5409 LEARY AVE

RECOMMENDATION
07/29/2019 #3030110-LU

EARLY DESIGN GUIDANCE RESPONSES

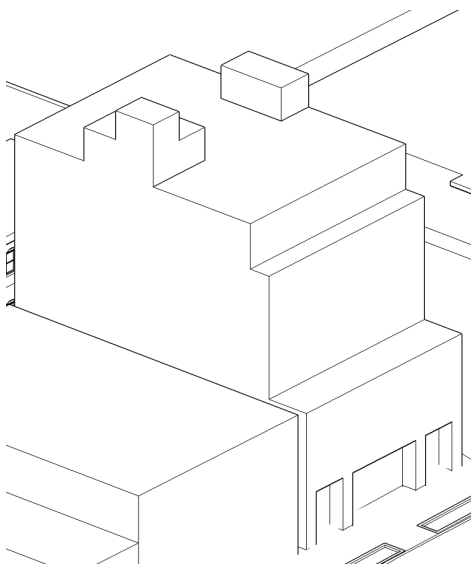
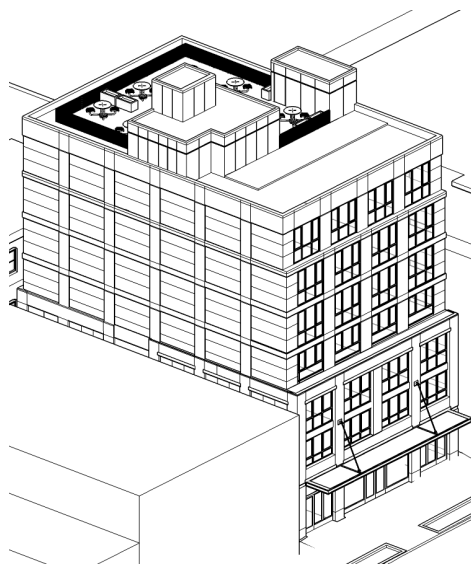
- a. The Board reviewed the three options presented and offered the following guidance. Options A and B similarly proposed a two-story ground level expression with simple massing, the difference being Option B included the required upper level setback above 65-feet. Option C introduced a new massing language with ground level courtyard at the street and vertical modulation.

- b. The Board agreed that Option C was the least preferred, noting that the massing was an inappropriate response to the existing neighborhood historic context. Despite not supporting this option, the Board appreciated its nod to the detail of the adjacent King’s building. (Applicable Guidelines)

- c. The Board supported Options A and B, with simple massing and appropriate response to the existing neighborhood character with two-story ground level expression and response to adjacent datums. The Board appreciated the full context analysis provided in the EDG packet.

- d. While supporting Options A and B, the Board acknowledged public comment expressing concern about the proposed height and agreed that additional information was necessary to fully portray the merits of the preferred Option A which required a departure to eliminate the required upper level setback above 65-feet. The Board surmised that there could be an option that merges A and B with a setback parapet or other move to mitigate perceived height. The Board requested that additional evidence be included in the Recommendation packet. Clearly demonstrate how the preferred design better meets the intent of the Design Guidelines and mitigates impacts of perceived height, bulk, and scale while maintaining a simple massing.

The proposed design represents a blend of options A & B, with the overall massing more resembling Option B and including a street-facing setback at both level 4 and level 7, in response to the board’s guidance to provide a setback or other move to mitigate the perceived height of the seventh story. The street-facing façade is pulled back from the east property line, enhancing the opportunity for the commercial uses to spill onto the sidewalk, as well as preserving some of the visual interest of the King Hotel building’s north façade.

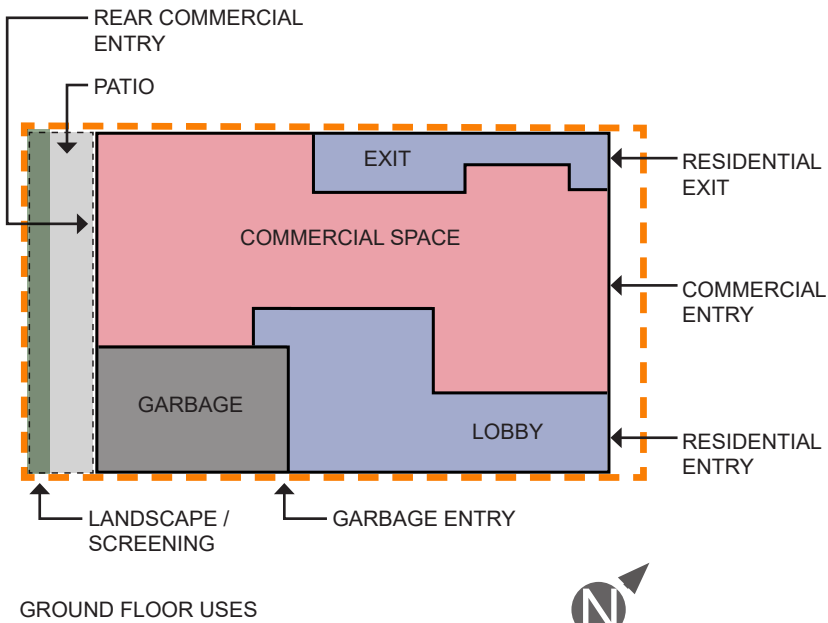
- a. Given the narrow width of the site, 46-feet, the ground floor program was relatively limited and resulted in a number of similarities between Options A and B. For example, both proposed a commercial space at grade, sandwiched between the residential lobby and exit passageway, and a garbage storage room accessed along the south property line. Differences included the location of the residential lobby and the bicycle storage room.

- b. The Board discussed the functionality of the ground floor program and how the floor plan might relate to the adjacent use to the south, Café Fiore. The Café Fiore building is setback approximately 3’-9.5” from the share property line and currently provides pedestrian access to the building. Both Options A and B propose utilizing this walkway to provide access to the garbage store room.

- c. While some members of the Board initially supported the residential lobby at the north end of the frontage (as proposed in Option A, page 28 of the EDG packet), others felt a clustering of services (garbage store area and bicycle storage area) was more important (as proposed in Option B, page 32 of the EDG packet). Ultimately, the Board agreed a clustering of services uses was important and could work with the residential lobby at either the north (Option A) or south end (Option B) of the frontage.

- d. A rear patio was proposed in Option A and B, in response to existing adjacent conditions. As shown on pages 28-29, there is an adjacent ground level open space to the west and south of the site. The Board appreciated the ground level study provided in the packet and agreed that setting the building closer to the street to accommodate a ground level open space in this area was an appropriate response to the existing context for a strong street edge and to contribute to the existing network of open spaces.

- e. The Board acknowledged public comment that recommended this space be carefully designed to ensure adequate space for usability, and requested information be presented at the Recommendation meeting describing the space. The Board questioned how the space will be programmed and designed. Ultimately, the Board agreed the space could provide a great synergy with the adjacent uses, and provide a delightful response honoring the historic context.

The ground floor in the proposed design clusters the residential lobby, and garbage area on the south portion of the site, similar to option B presented during the EDG meeting. This configuration allows the commercial area to stretch all the way from the street-facing façade on Leary Ave NW, to the rear patio to the west. The rear patio maintains the neighborhood pattern of ground level open space at the rear of the structures (these open spaces are documented on page 49). The ground level patio is 10 feet wide, with planters and screening along the west property line to better define the space. The ideal application would be intimate, well-detailed outdoor seating for a restaurant. Horizontal wood siding on the level 1 façade adjacent to the space add warmth and human-scale to the space, with opportunities for restrained lighting and seating to improve the functionality of the space. Additional information and graphics showing the space will be provided in the forthcoming recommendation packet.

ELEVATION | SOUTH

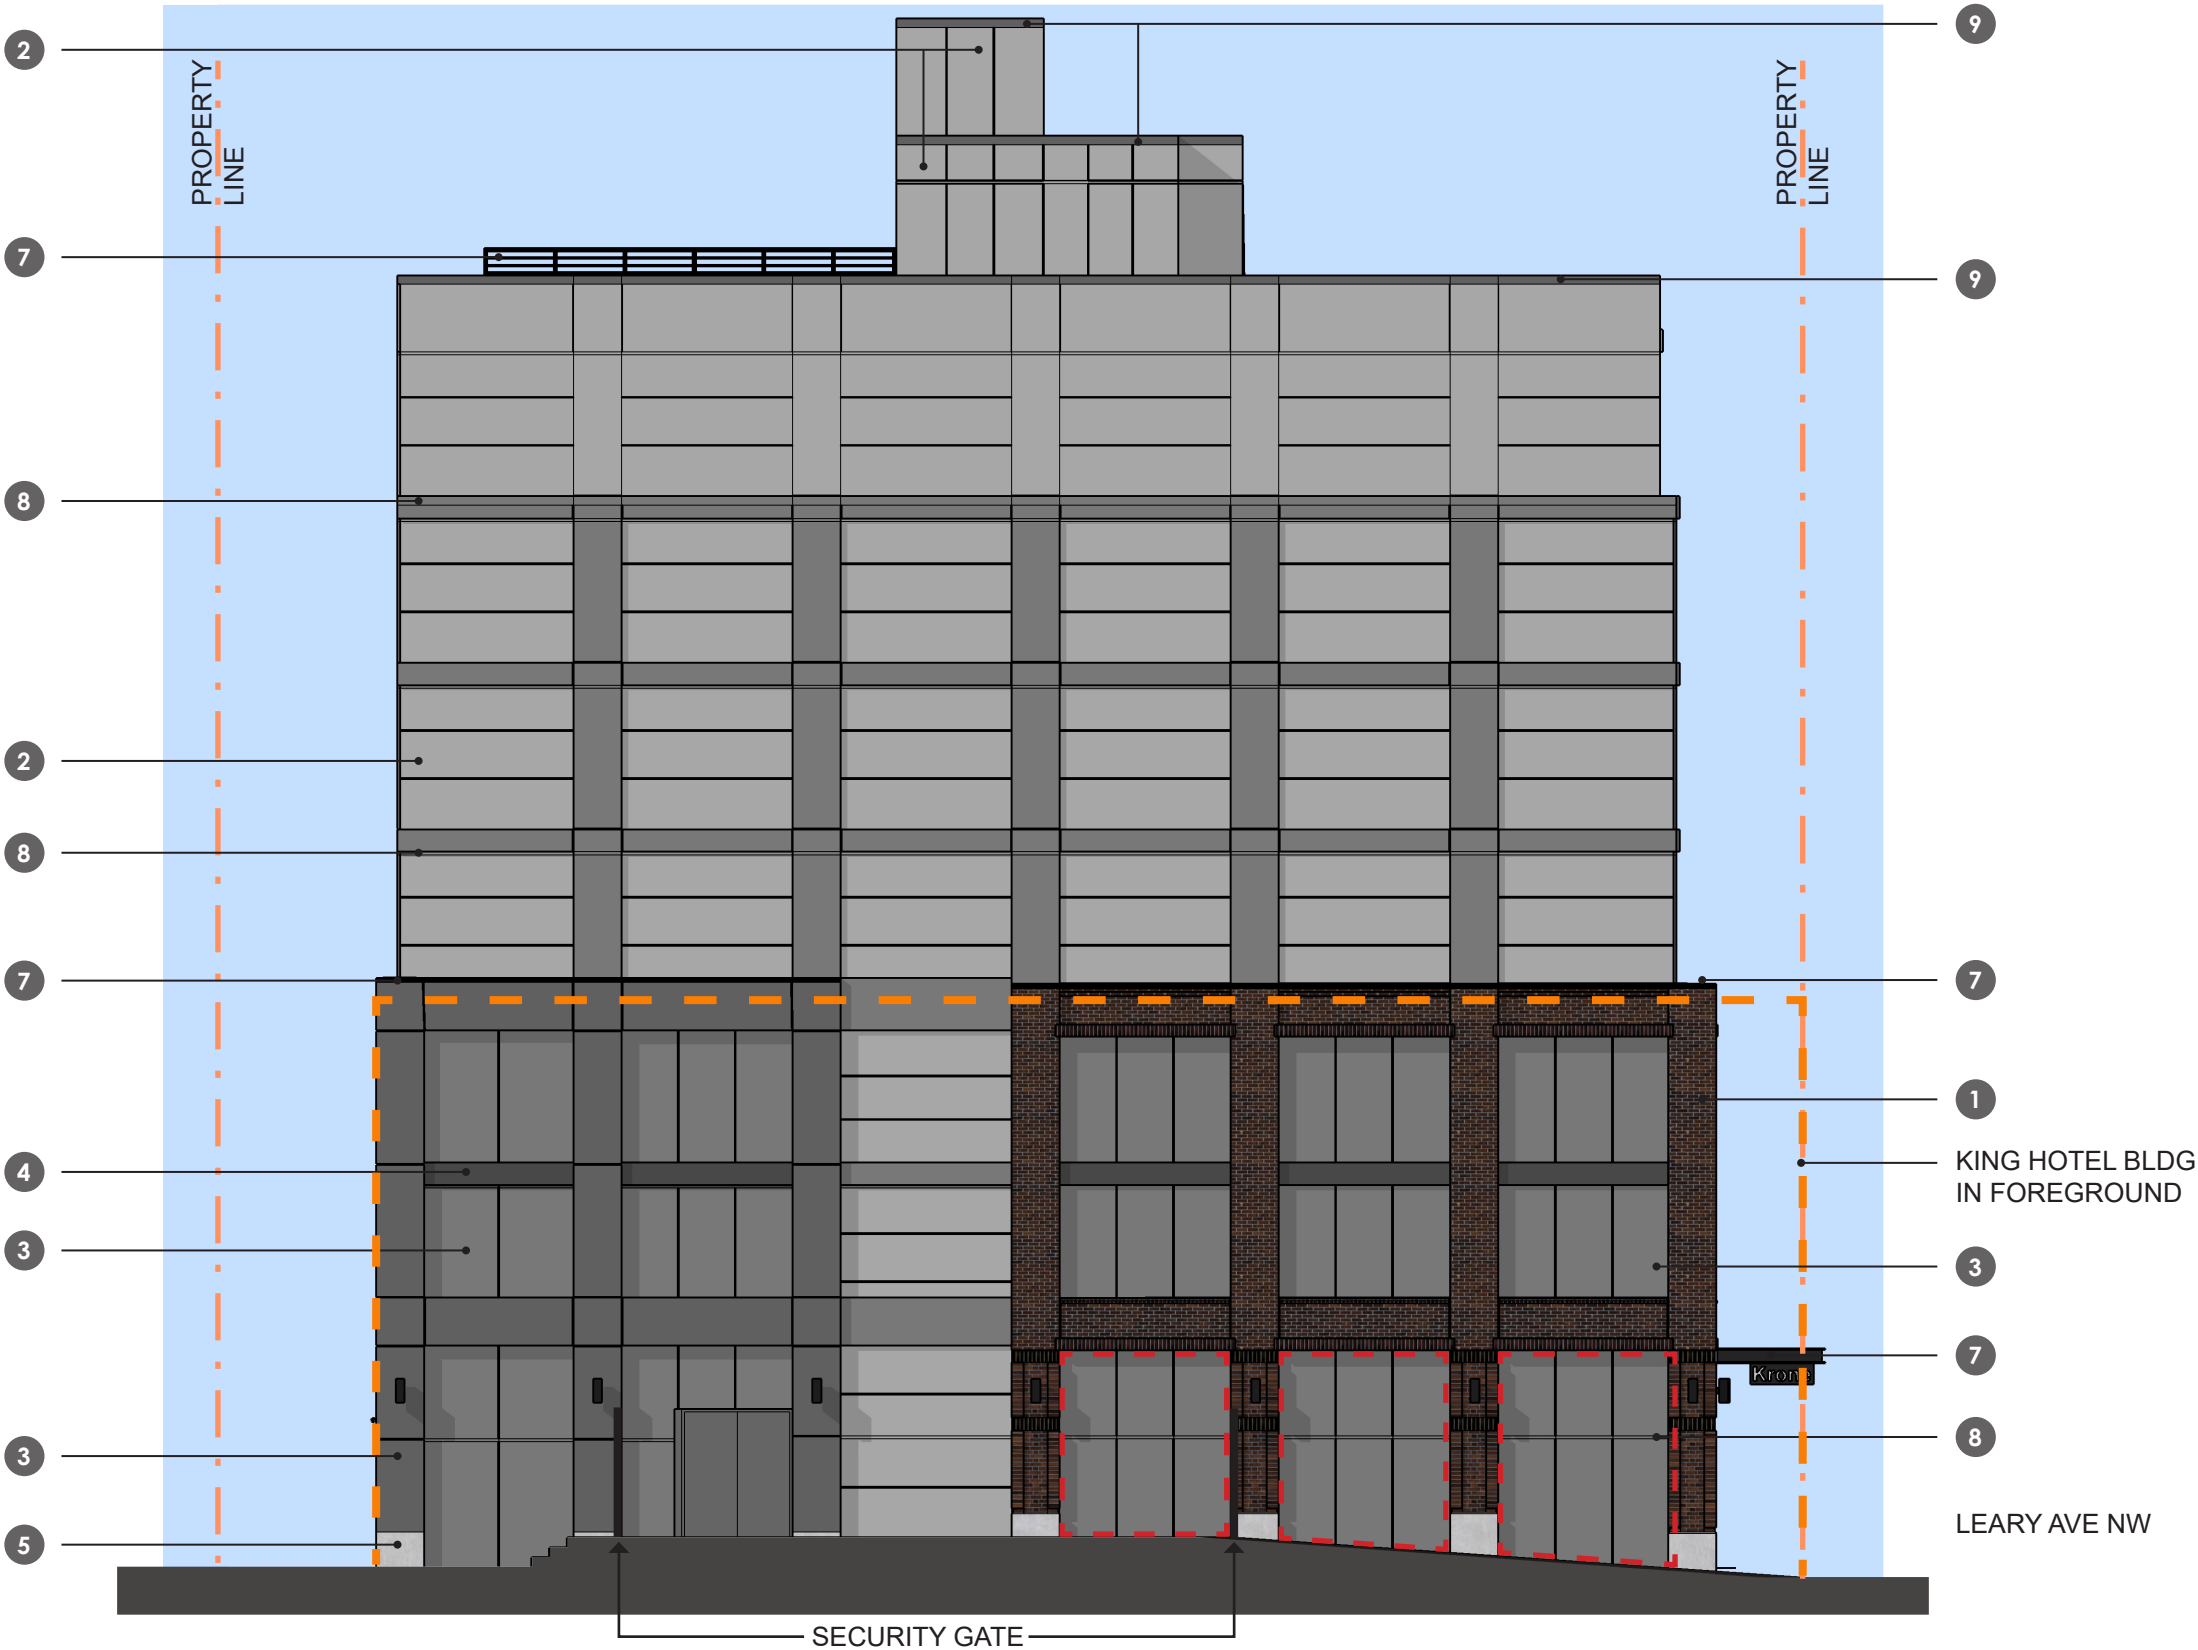
- b. As noted on page 4, a 3'-9.5" wide pedestrian path was located between the site and the existing Café Fiore building to the south. This pathway informed the Board's guidance related to the treatment of the south elevation. Because this pathway will increase the visibility of this elevation, both from the street and from users of the pathway, the Board agreed that careful attention to the materiality of this elevation at the ground level is important. Page 21 (*Page 51 in this packet*) of the EDG packet contained four south façade studies, each illustrating a brick frame expression with a variety of reveal patterns above. The Board appreciated this analysis and supported the applicant's proposal to provide visual interest to the upper level façade while relating to the architectural expression below and on the street facing façade. The Board suggested wrapping brick from the front façade around to this elevation and carefully considering how the material will wrap again at the rear elevation.

- c. The four south façade studies on page 21 each proposed a brick frame with what appeared to be fiber cement infills or voids. The Board agreed these voids should be brick, not fiber cement. All facades should reflect a coherent composition.

The south façade has been further developed, per the board's guidance, with the brick frame expression from the street-facing façade wrapping around to the south façade. Within the frames on level 1 is a recessed field with the opportunity of displaying street art, creating a highly tactile and detailed pedestrian realm. The infill within the brick frames has been maintained as fiber cement, with additional detail and visual interest provided through expressed material joints. Since the infill is nearly coplanar as the material above, and due to the relatively small size of the building, the design team felt it is more successful to have the panels from above stitch into the frame, rather than carrying the brick veneer up or introducing a new material. The brick frames wrap approximately ¾ of the south façade, where a "gasket" aligned with the service entry creates a break between the brick frame and a rear frame. , The rear frame shares the same proportions and height, allowing the three-story base expression to wrap the back of the building in a contiguous, coherent way. The upper stories utilize the frame expression proportions to locate fenestration (on the east and west facades) and locate panel lines and modulate the materials (on the south façade and visible portions of the north façade). The consistent patterning between the base and upper stories stitches the building together to create a unified, coherent architectural composition.
